**SITE PLAN WITH AERIAL**  
**WEBER CARPET**  
 LEE'S SUMMIT, JACKSON COUNTY, MISSOURI

Re: Responses to City Comments  
Commercial Preliminary Development Plan, PL2017064  
PEI # 170069

**Analysis of Commercial Preliminary Development Plan:**

SHEET  
C2

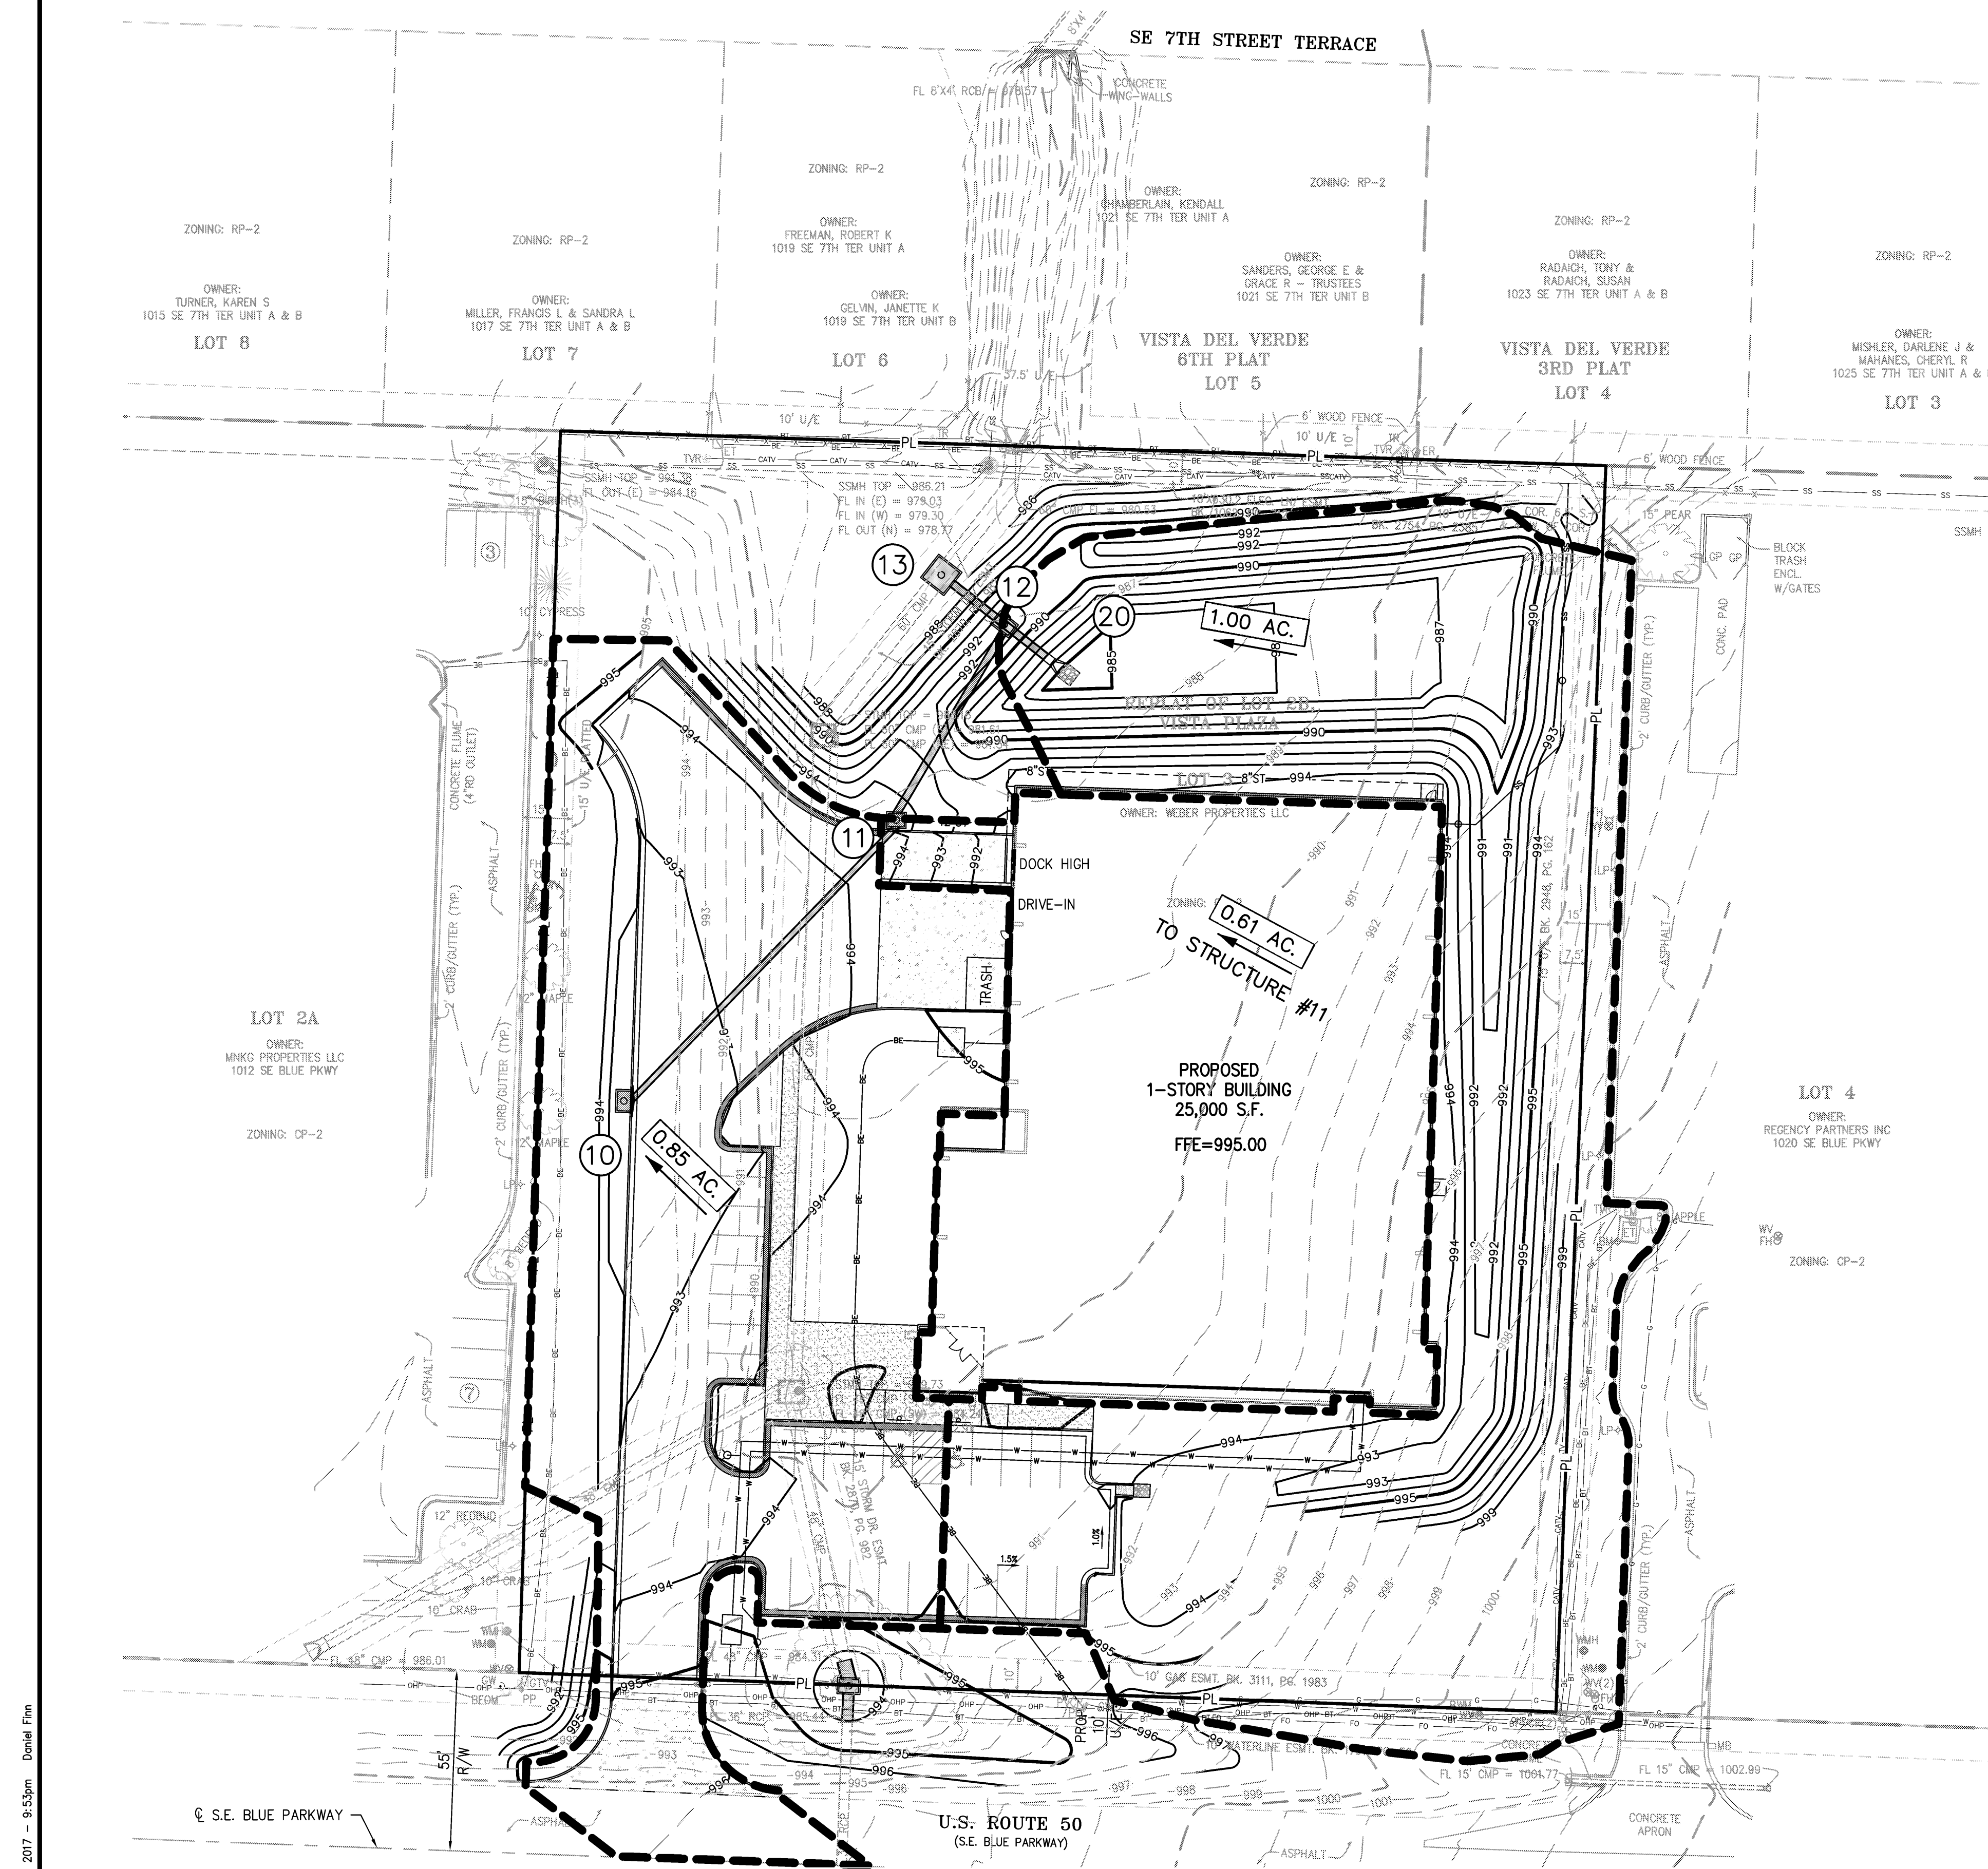
4. Sheet C2: A retaining wall is shown over the of a public stormwater pipe and easement. This is a non-allowed use in accordance with the encroachment policy. It appears this area will need to be filled-in, and the stormwater pipe should be connected from the City-owned stormwater system, to the system owned and maintained by MoDOT. As such, a permit from MoDOT would be required prior to approval of the Final Development Plan.

5. Sheet C2: Please label the detention basin as "Detention Basin and Water Quality Basin".

*Response: Acknowledged. The landscape wall has been removed. A public area inlet has been added to the plans to connect the two public storm sewer structures. See Sheet C5A.*

*Response: Detention basin label has been revised on Sheet C2.*

**Landscape Plan**  
**Weber Carpet**  
 Lee's Summit, Missouri

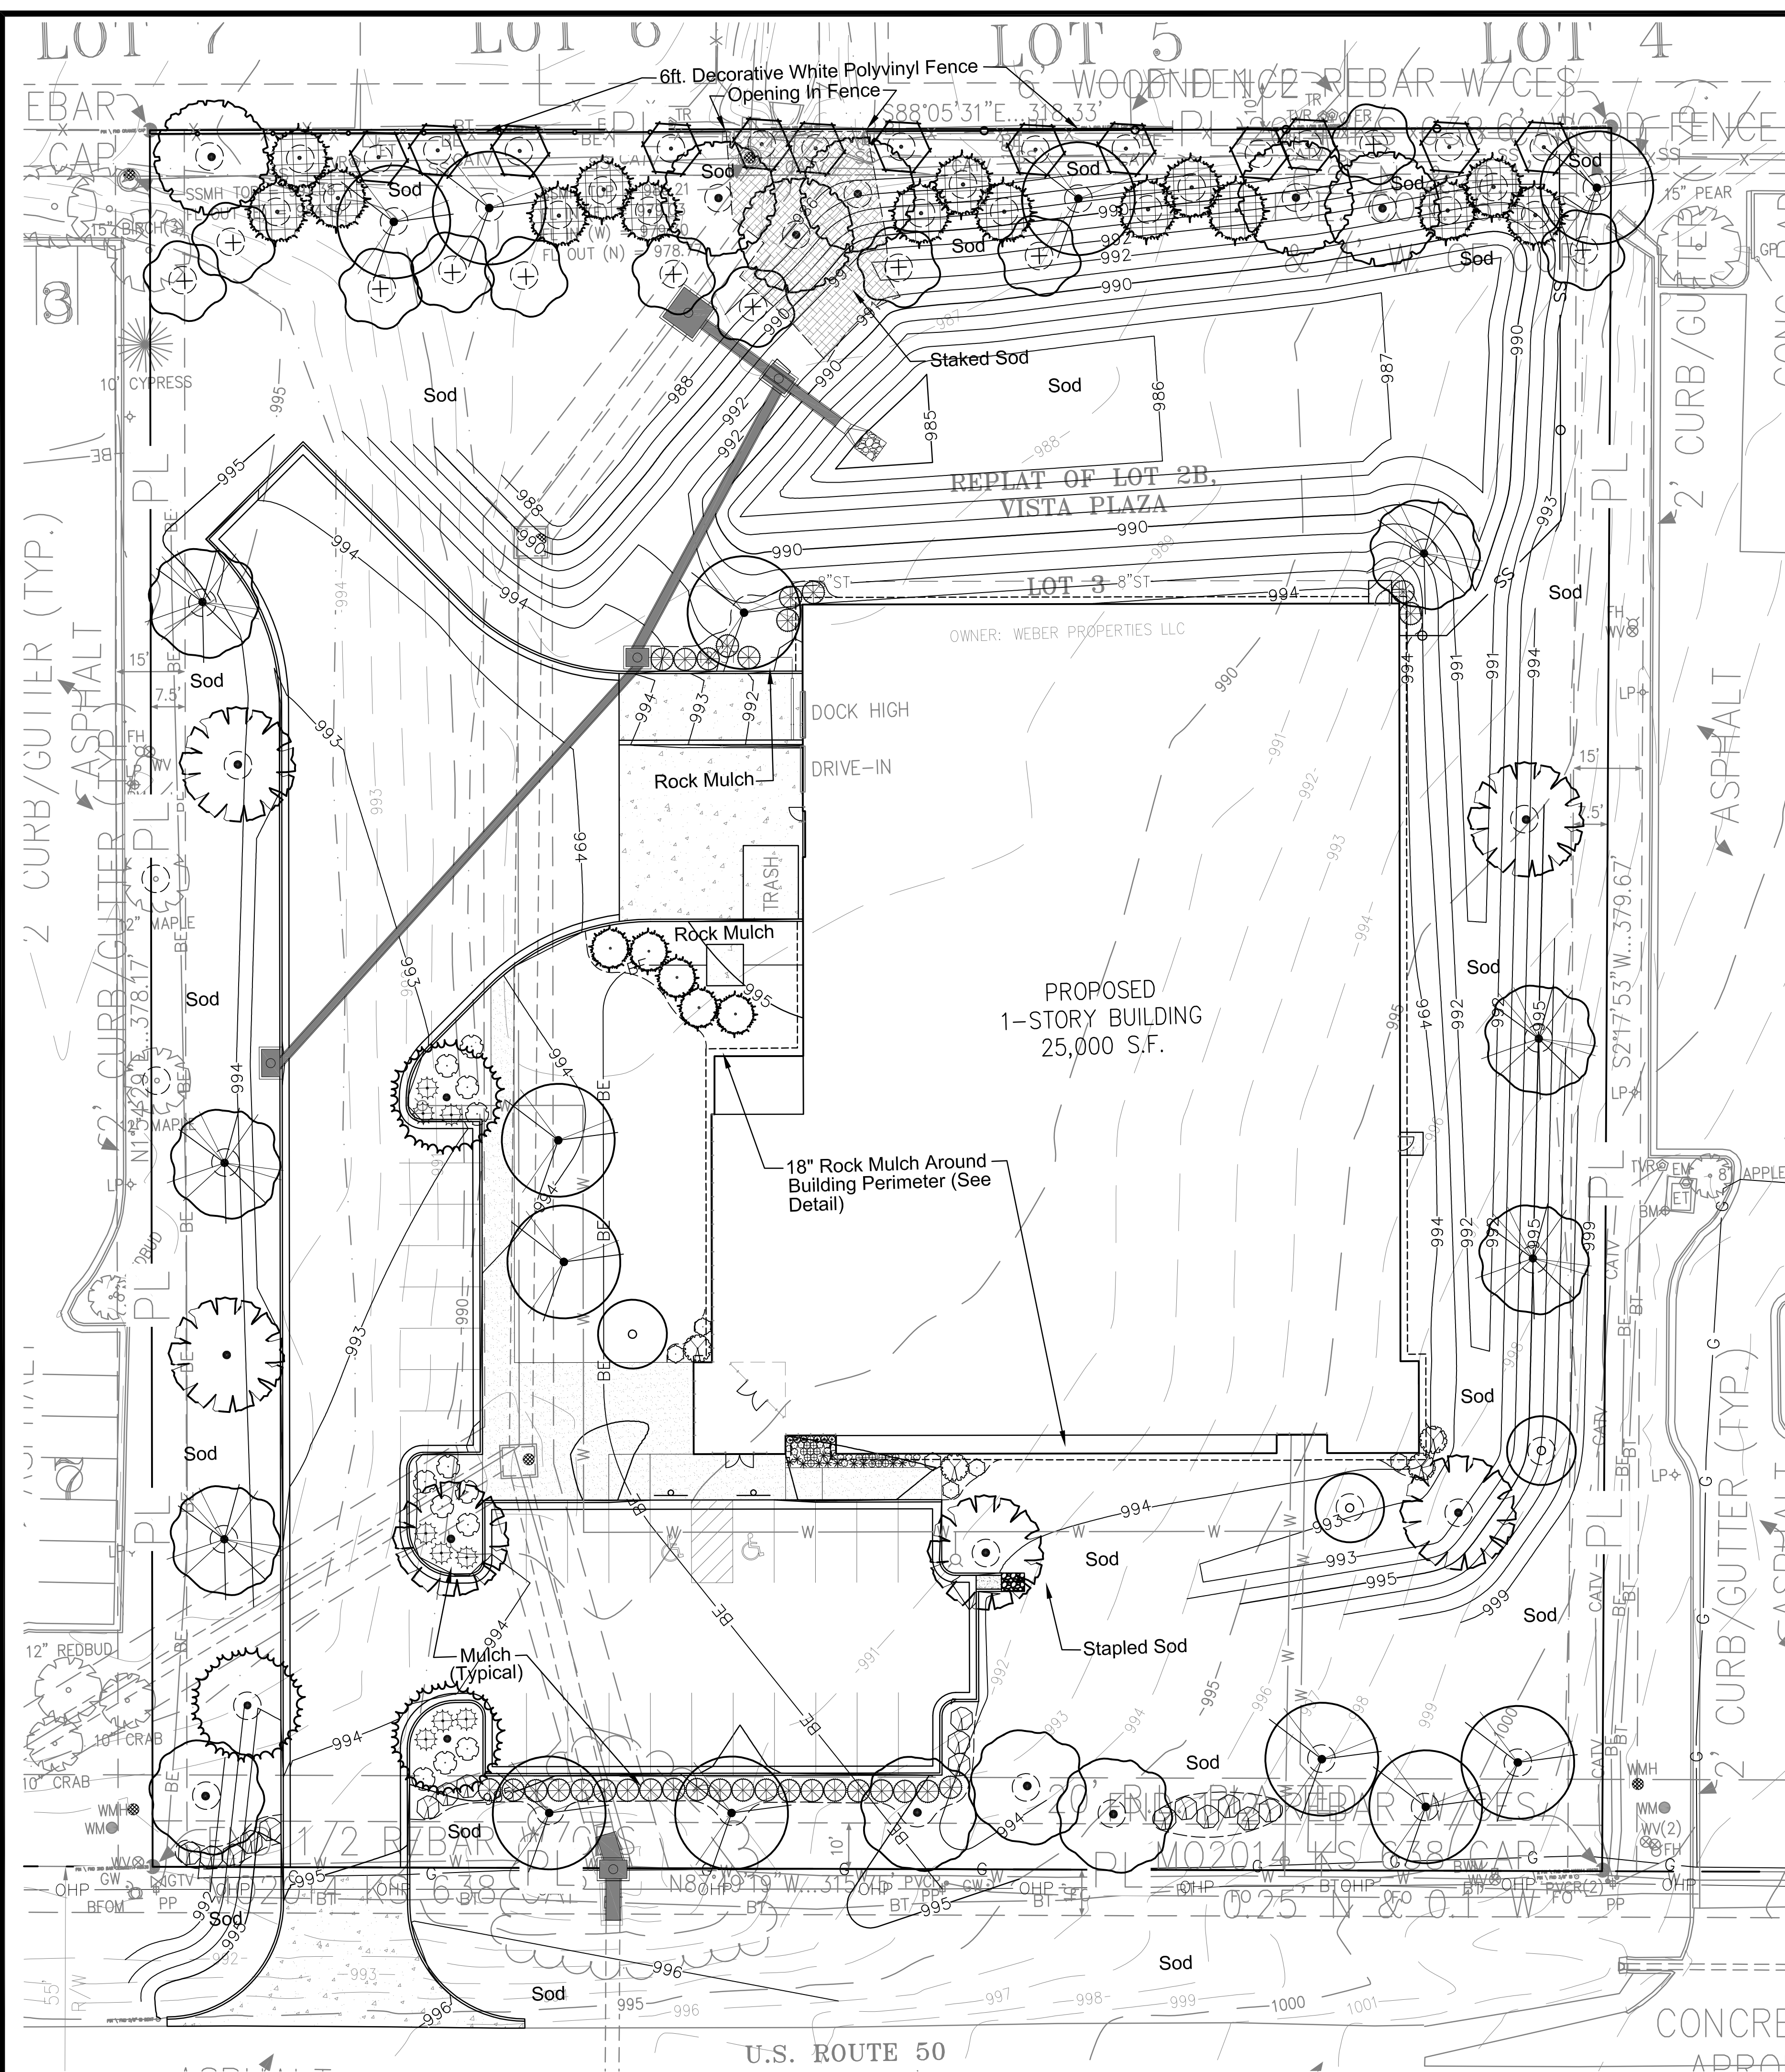
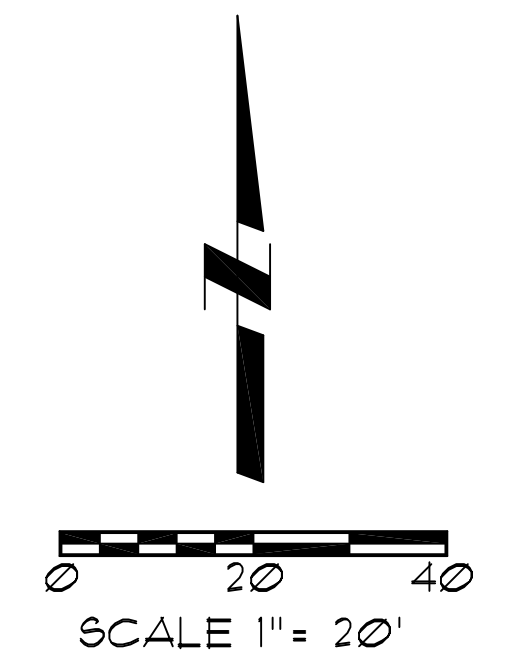
16. On the landscaping plan, the trash enclosure location is adjacent to the loading dock. This is inconsistent with all other sheets. Please advise if this is correct.

17. The landscaping for the high impact screening is required to be planted on both sides of the fence. Staff does not have the authority to make deviations from the ordinance, if you wish to keep the fence on the property line with landscaping on one side you may ask for a modification from the Planning Commission/City Council by submitting a narrative statement that explains the need for modification.

19. Deciduous trees shall be a minimum of 3 inch caliper measured at a point 6 inches above the ground or top of the root ball, at planting and evergreen trees shall be a minimum height of 8 feet at planting. The plant schedule shows the Bald Cypress is only 2" caliper and the Canaerti Juniper is only 6' tall. Please adjust this to meet minimum requirements.

11. Landscape Plan: It appears there are at least two (2) trees too close to the water main near the new commercial entrance. The minimum distance between a tree and a water line is five (5) feet, as measured from the mature tree trunk to the outside of the pipe.

*Response: The trash enclosure is to be adjacent to the loading dock. The plans have been updated to match.*

*Response: See attached request to code modification.*

*Response: The plant schedule has been updated accordingly.*

*Response: Trees have been relocated away from the water line.*
